Intel® Mobile Celeron™ Processor at 500 MHz, 450 MHz, and 400A MHz Specification Update

Release Date: March 2000

Order Number: 245421-002

Figure 6. BCLK Timing Waveform

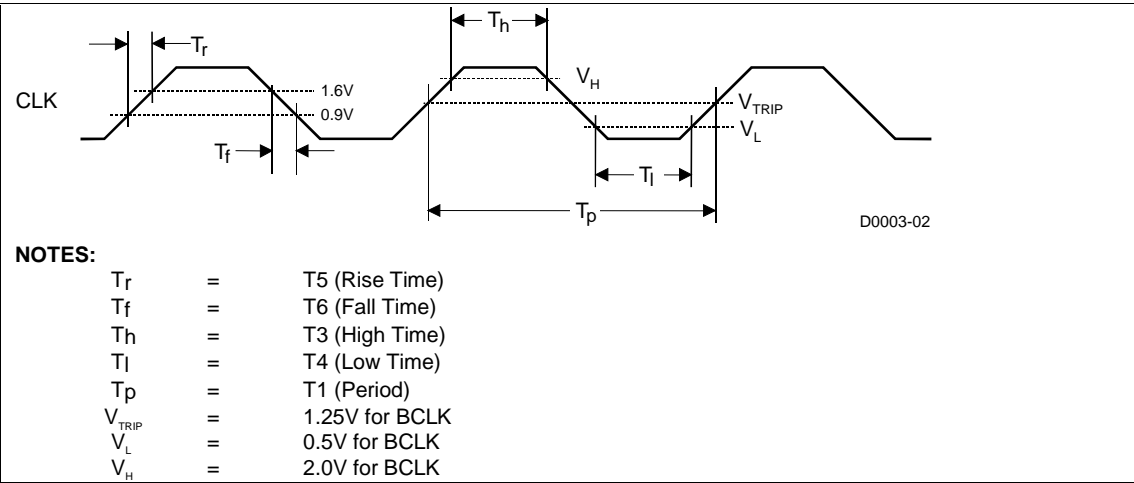
For B0 step processors, the $V_{IH,BCLK}$ Min spec is changed to 2.0V (from 1.7V for A2 step) and $V_{IL,BCLK}$ Max spec is changed to 0.5V (from 0.7V for A2 step). Due to this, new values are specified for BCLK high and low times for B0 step processors. These modifications affect corresponding specs in Table 12, Table 13, Table 22, and Figure 6 in *Mobile Celeron™ Processor in BGA2 and Micro-PGA2 Packages at 500 MHz, 450 MHz, and 400A MHz* datasheet.

Symbol	Parameter	Min	Typ	Max	Unit	Figure	Notes
	System Bus Frequency		100		MHz		
T1	BCLK Period		10		ns	Figure 6	Note 2
T2	BCLK Period Stability			± 250	ps		Notes 3, 4
T3	BCLK High Time	2.70			ns	Figure 6	at >2.0V
T4	BCLK Low Time	2.45			ns	Figure 6	at <0.5V
T5	BCLK Rise Time	0.175		0.875	ns	Figure 6	(0.9V – 1.6V)
T6	BCLK Fall Time	0.175		0.875	ns	Figure 6	(1.6V – 0.9V)
